H11022

DESCRIPTIVE REPORT

Locality Miah Maul Shoal to Ben Davis Point

**Descriptive Report to Accompany
Hydrographic Survey H11022
Scale 1:20,000, Surveyed 2001
R/V OceanExplorer
Science Applications International Corporation (SAIC)
Walter S. Simmons, Hydrographer**

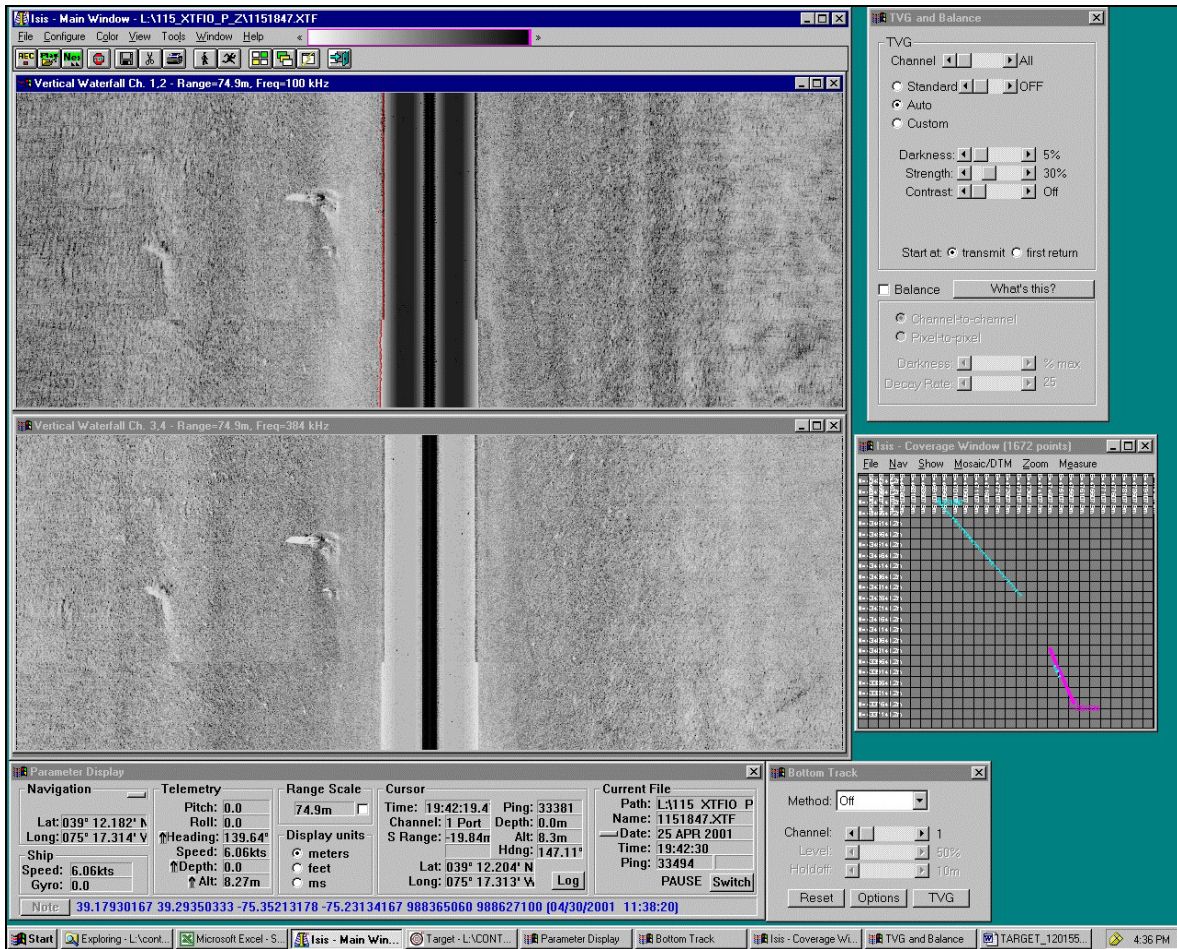
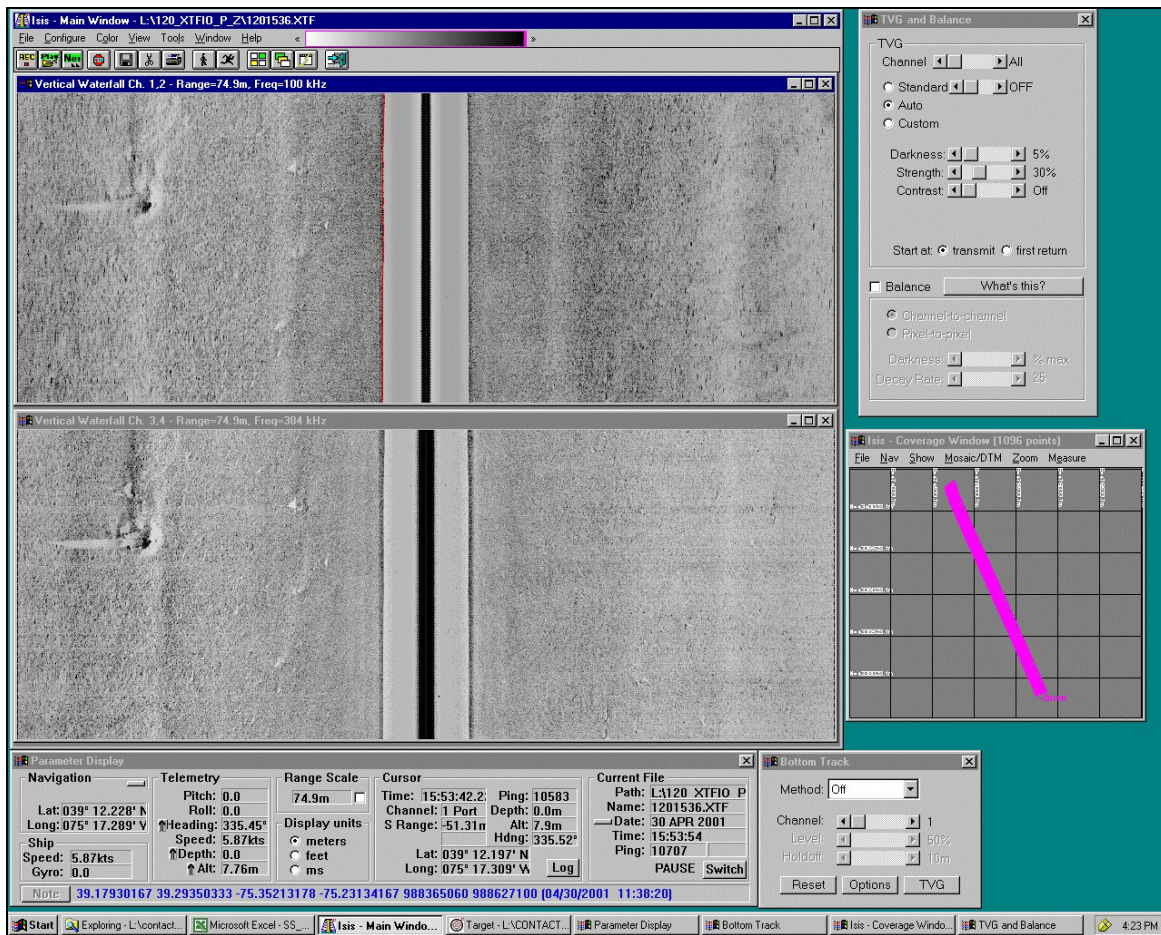
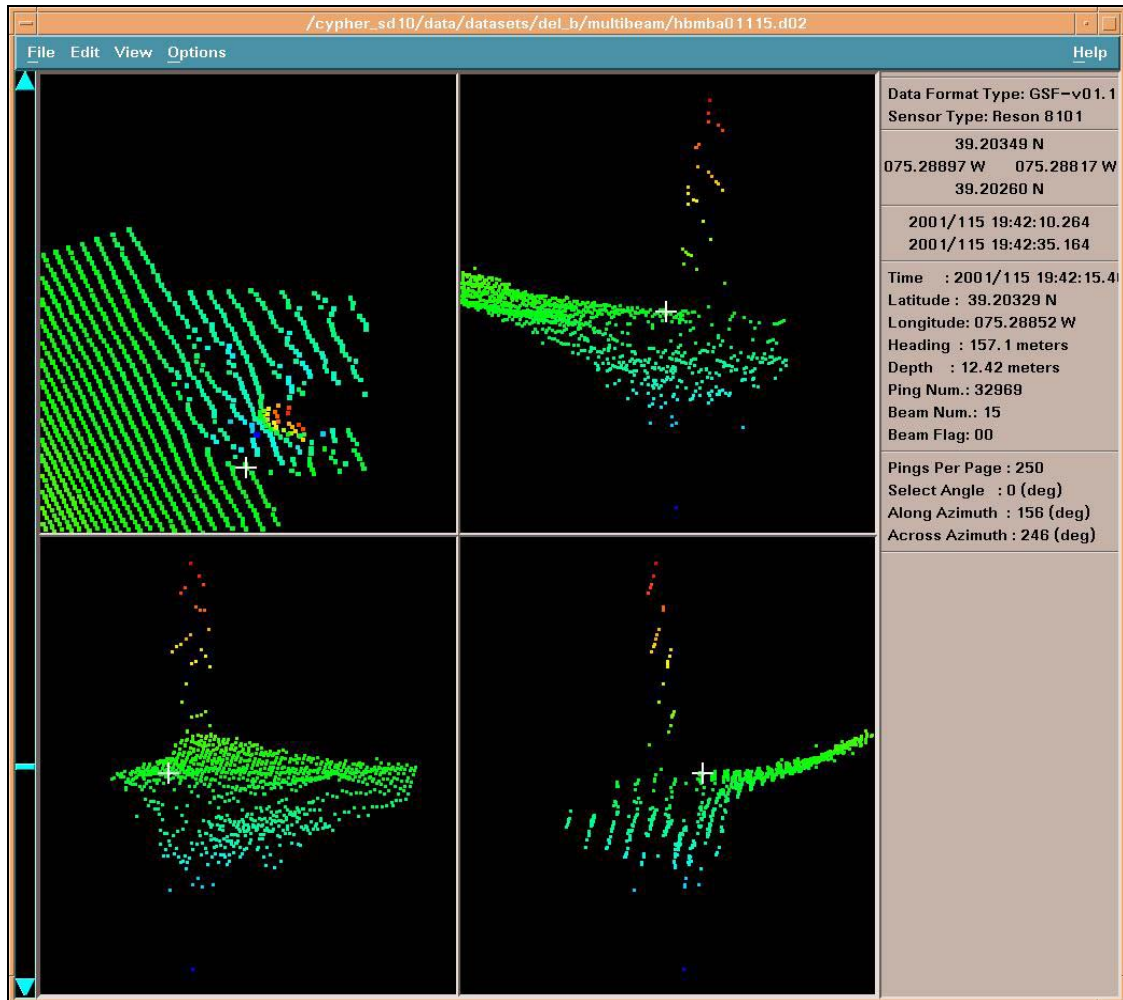
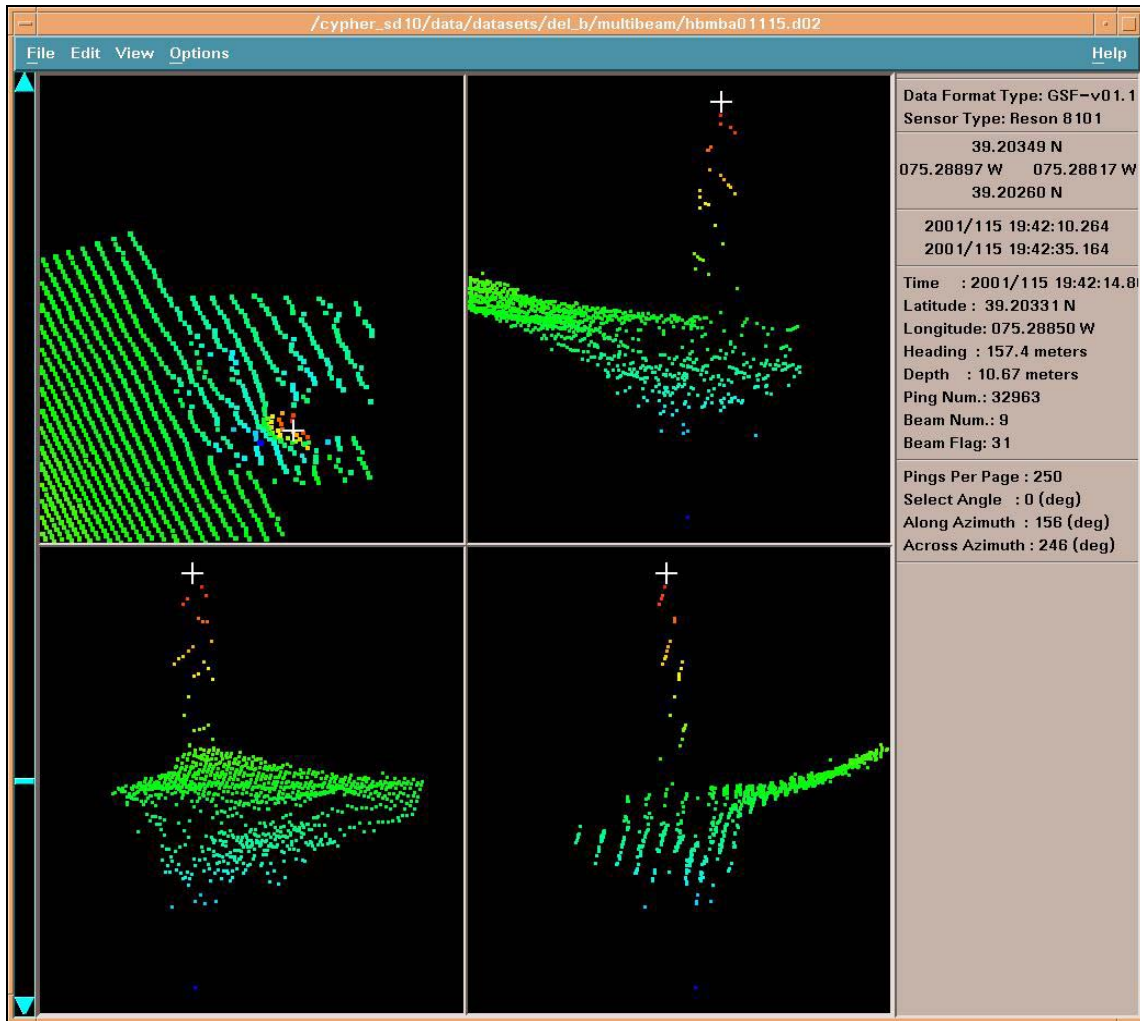
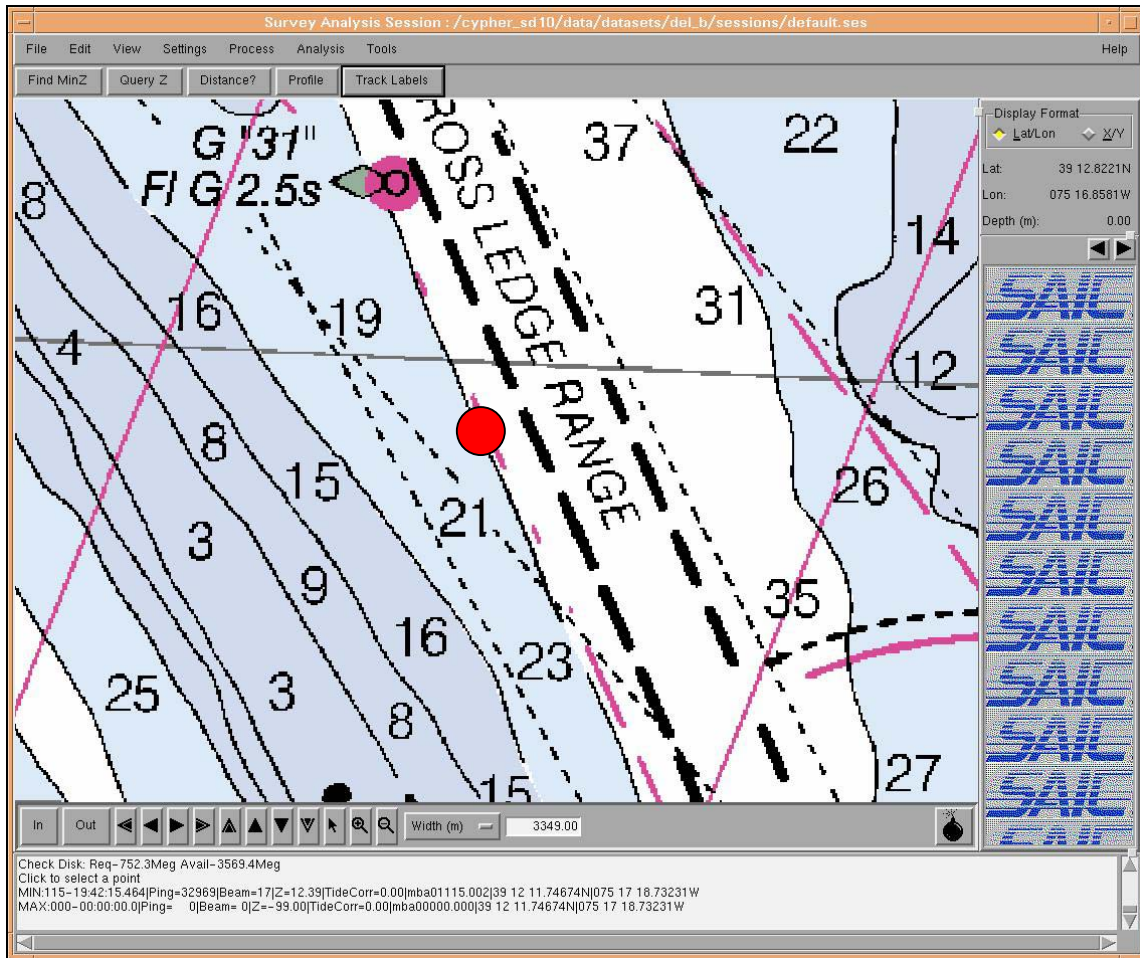
- Report 1 was submitted on or about 6 July 2001, and reported a 5.7 foot (1.75 meters) high obstruction with a minimum depth of 35 feet (10.67 meters) in 41 feet (12.42 meters) of water, at 39° 12' 11.92"N 075° 17' 18.60"W, NAD83, (*See Correlator Sheet for Feature #42) (*See Chartlet 7). This obstruction is nearest the channel of a group of obstructions. Recommend changing the charted Obstn label to Obstns. **Concur with clarification. Delete charted 35 Obstn, add 27 Obstns with danger curve in latitude 39°12'13.3"N, longitude 75°17'24.0"W. See also the Evaluation Report section D1b.**

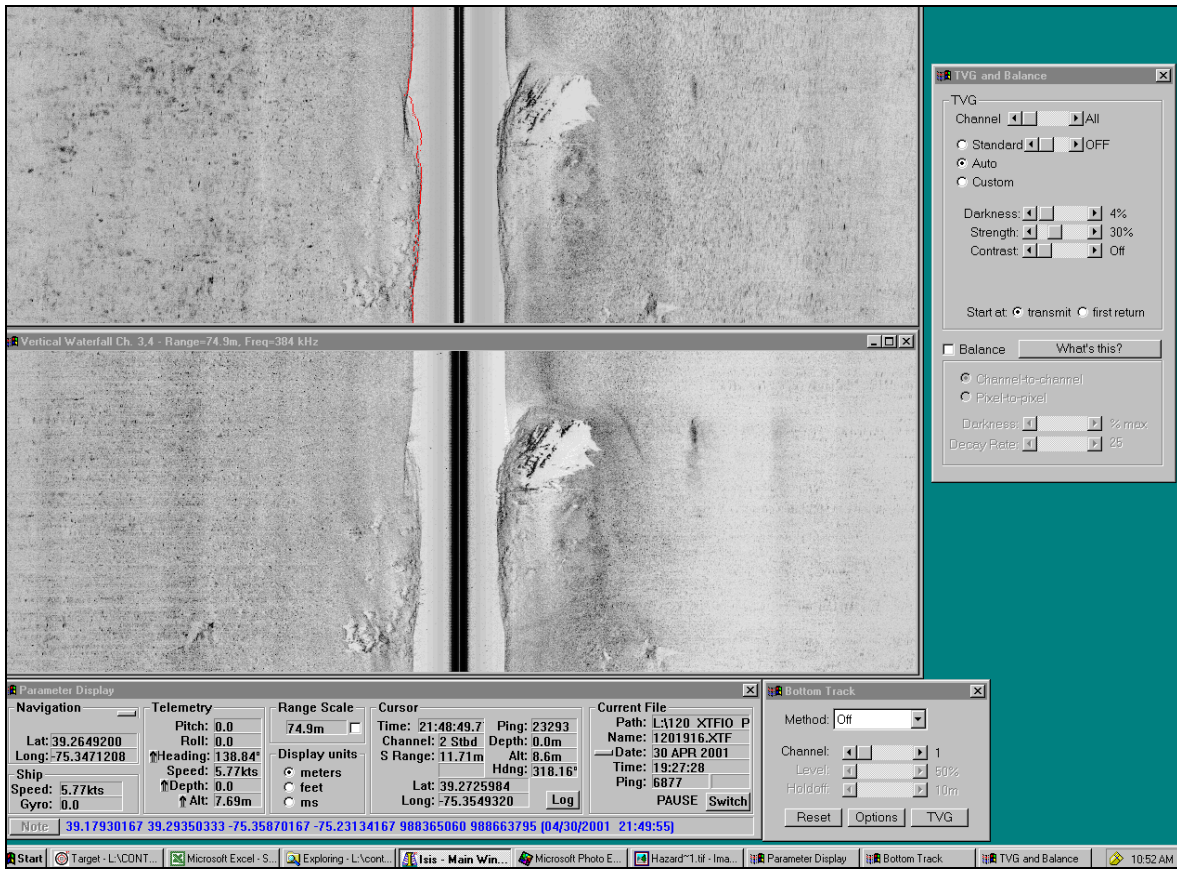
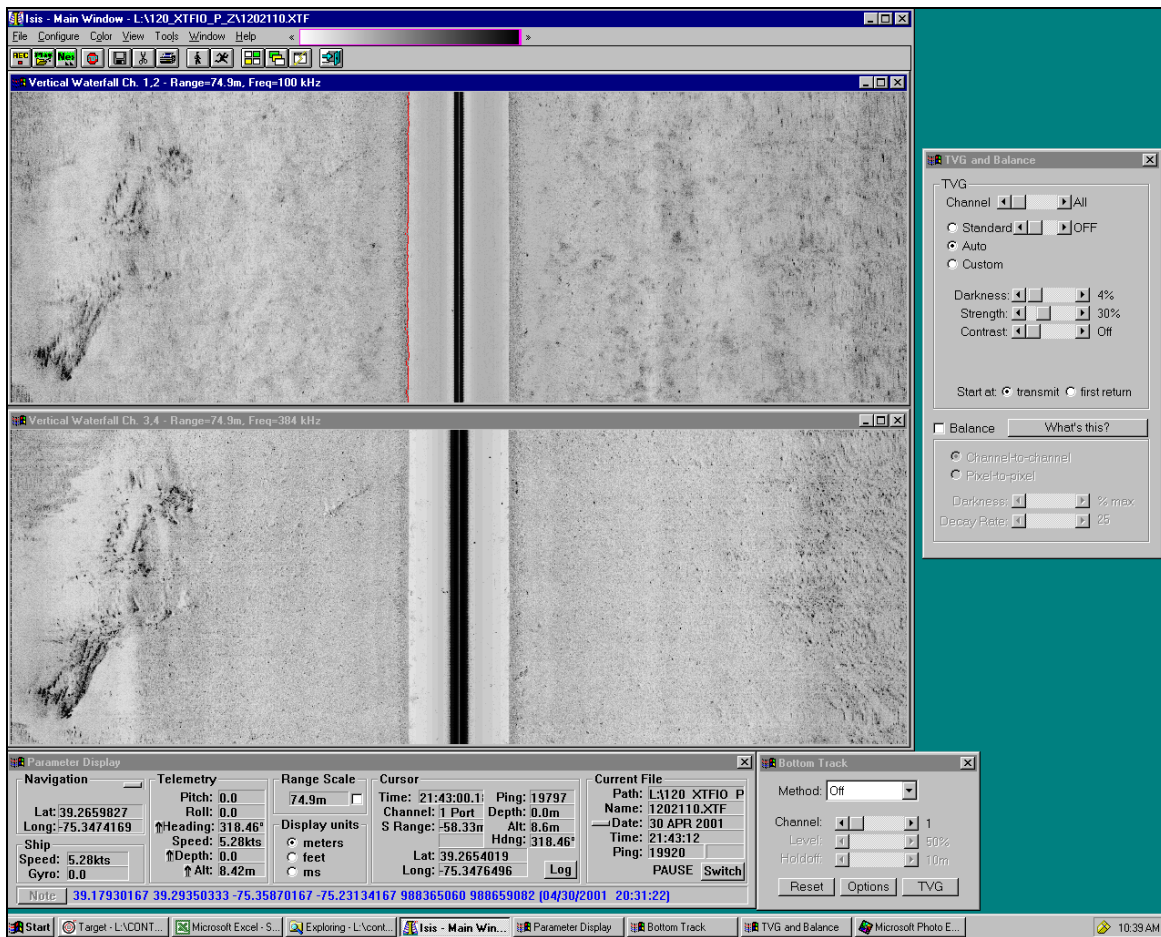
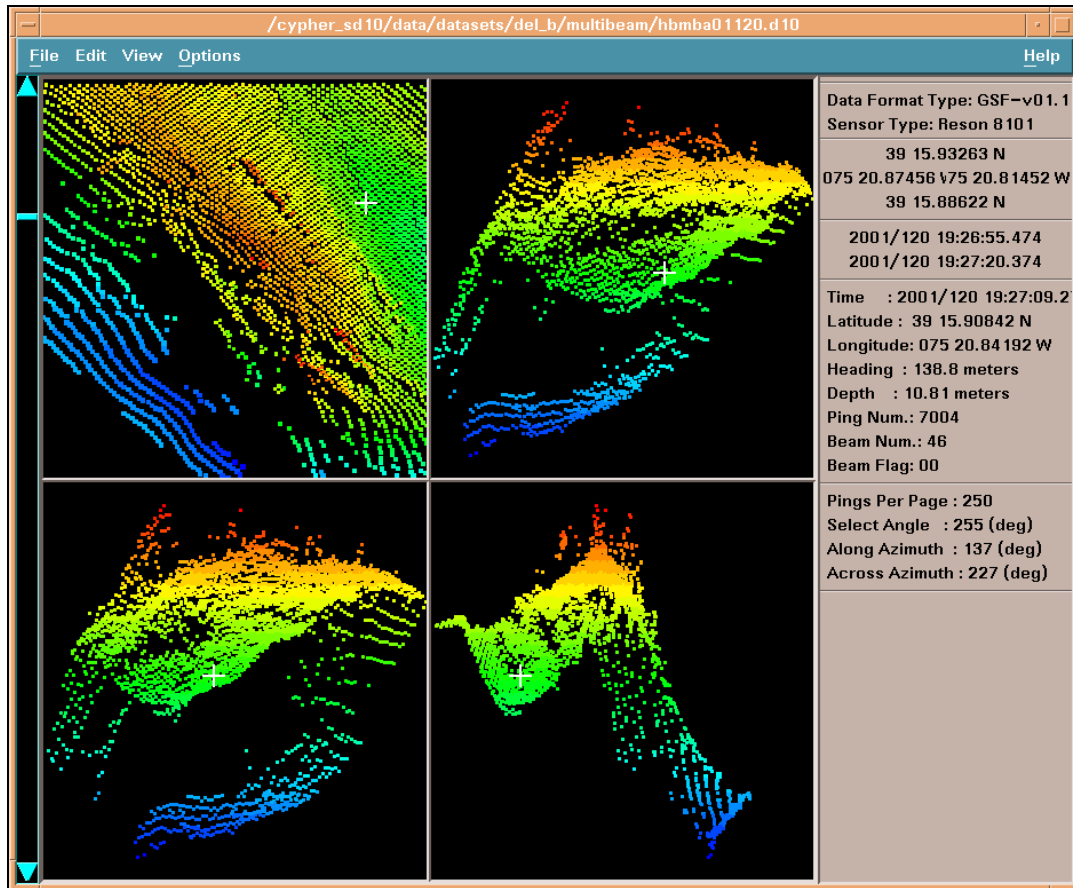
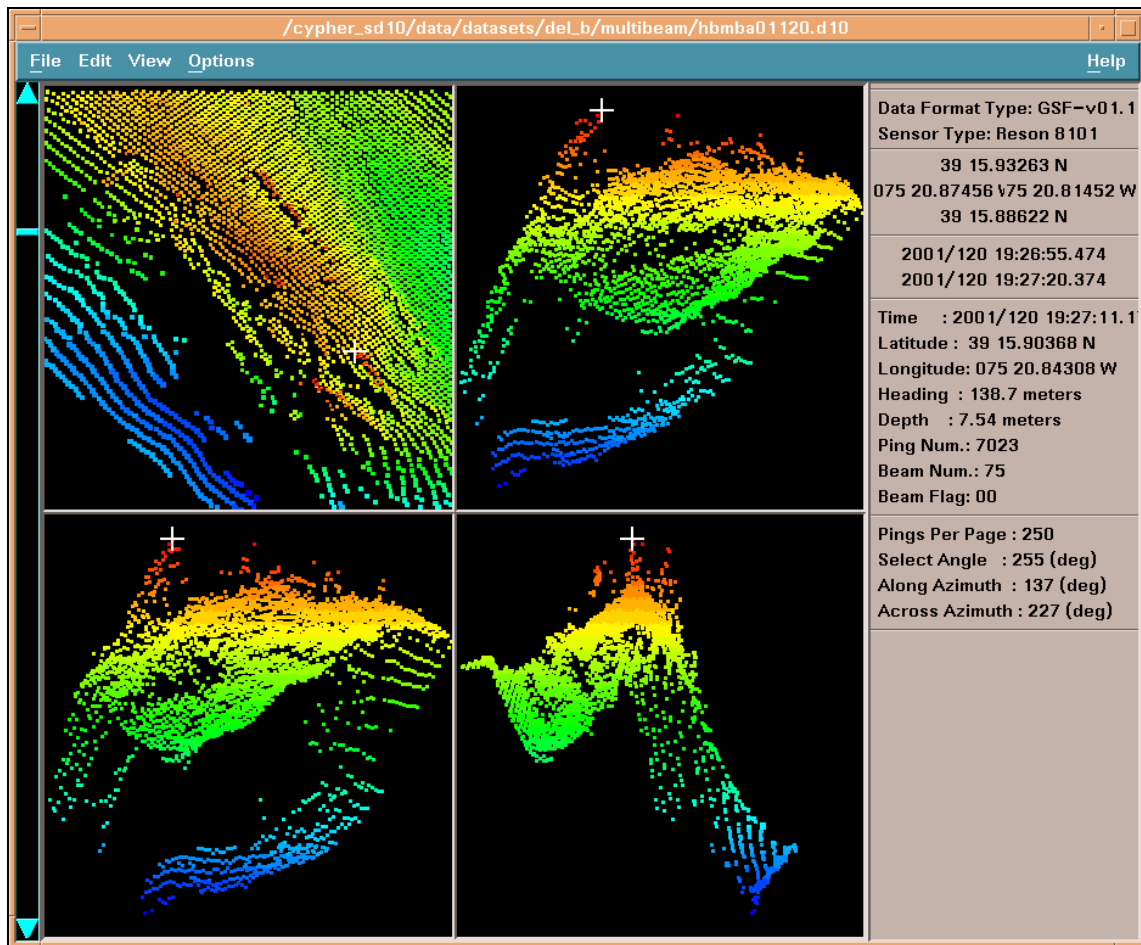
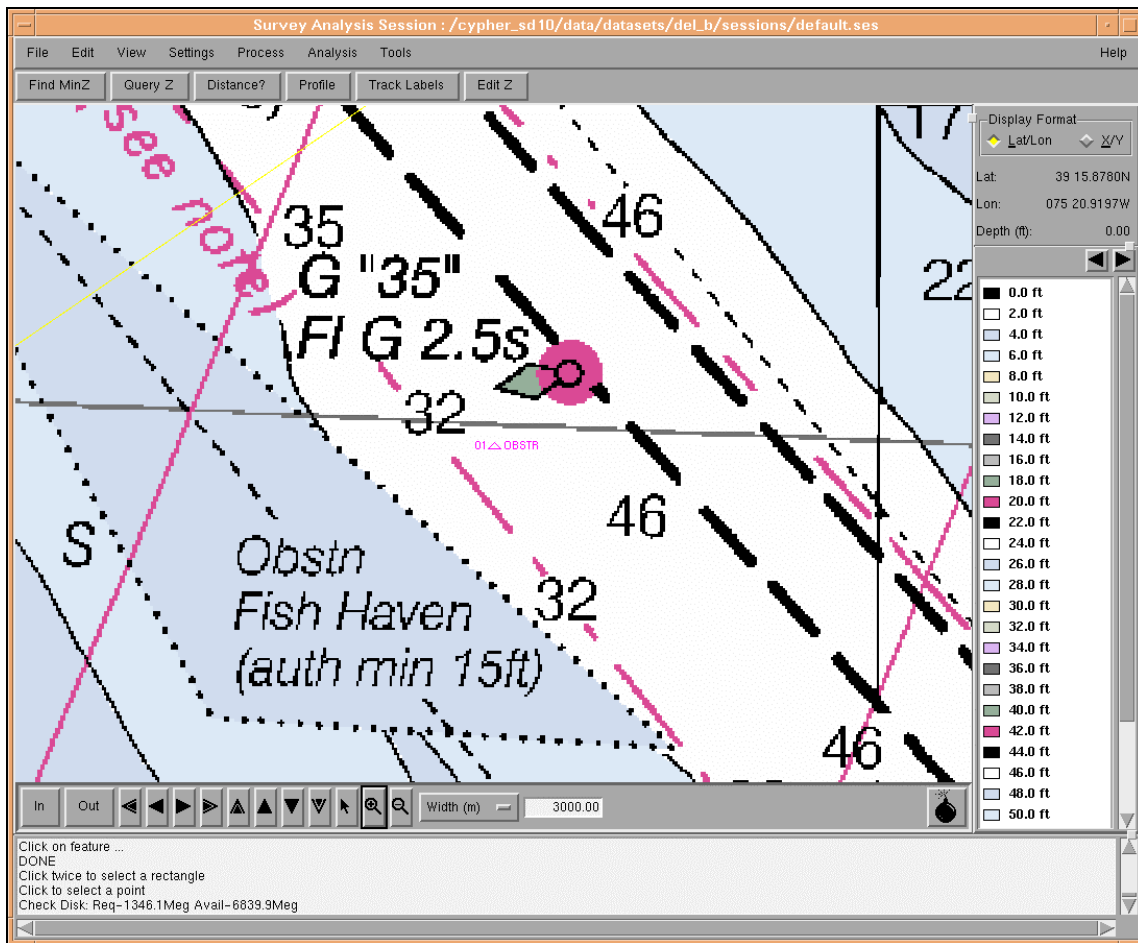
- Report 2 was submitted on 12 July 2001, and reported a 10.7 foot (3.27 meters) high obstruction with a minimum depth of 24 feet (7.54 meters) in 35 feet (10.81 meters) of water, at 39° 15' 54.22"N, 075° 20' 50.58"W, NAD83, (*See Correlator Sheet for Feature #1) (*See Chartlet 2). Further investigation revealed this to be a wreck. Recommend changing the charted Obstn to Wk. **Concur with clarification. Revise 24 Obstn to 24 Wk with danger curve as shown on present survey.**
